October 6, 1980

Re: Docket No. 71-6698  
NFS-4 (NAC-1) Spent Fuel Shipping Cask

In the interest of clarity and to provide a more quantitative criteria for assessing the stability of the NAC-1 spent fuel shipping cask inner cavity, we request Paragraph 14 of Certificate of Compliance No. 6698, Revision 11 be changed to:

Fig. 2.1 The chi-square test.

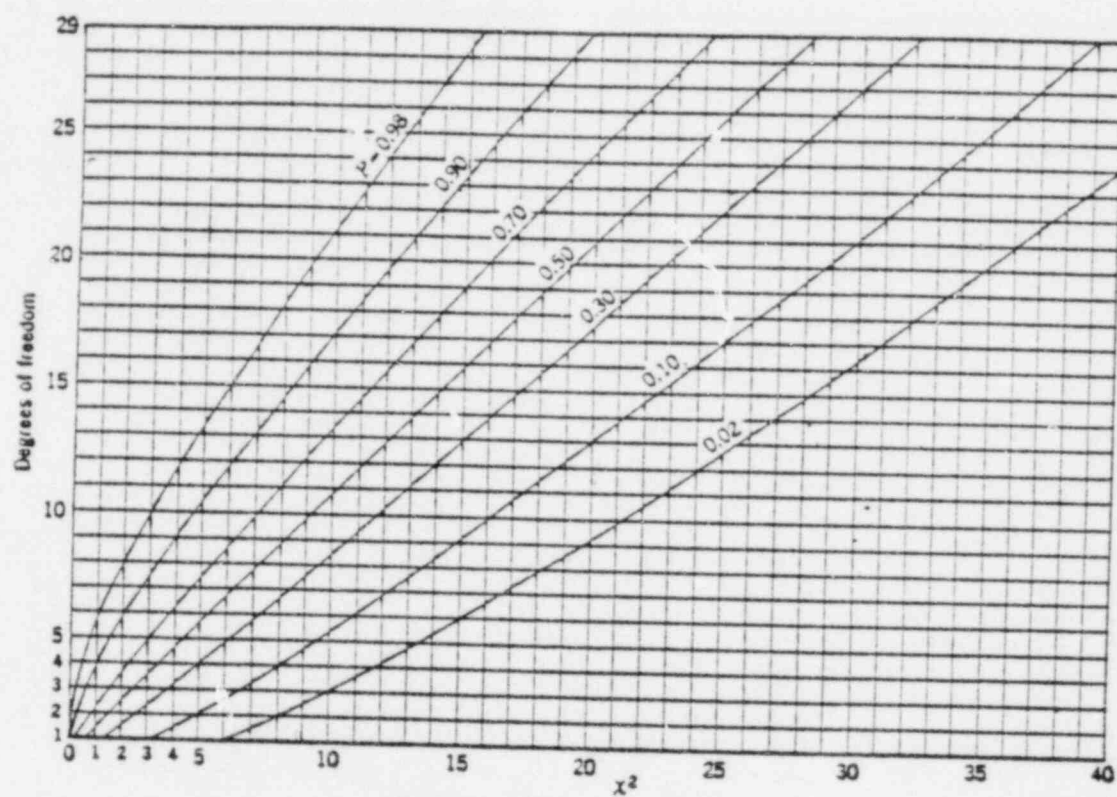
Figure 2.1 on page 776 of Reference 1 (attached) presents  $p$  as a function of  $\chi^2$  and  $F$ .  $F$  is the number of degrees of freedom, which in this case is two less than the number of different values of the diametral differences. Thus, the acceptable chi-square must result in a probability between 0.9 and 0.1 for the diametral differences to be considered as measurement error and not real dimensional changes. Satisfaction of this criteria provides confidence that there are no diametral changes which could reflect a change in the cavity configuration.
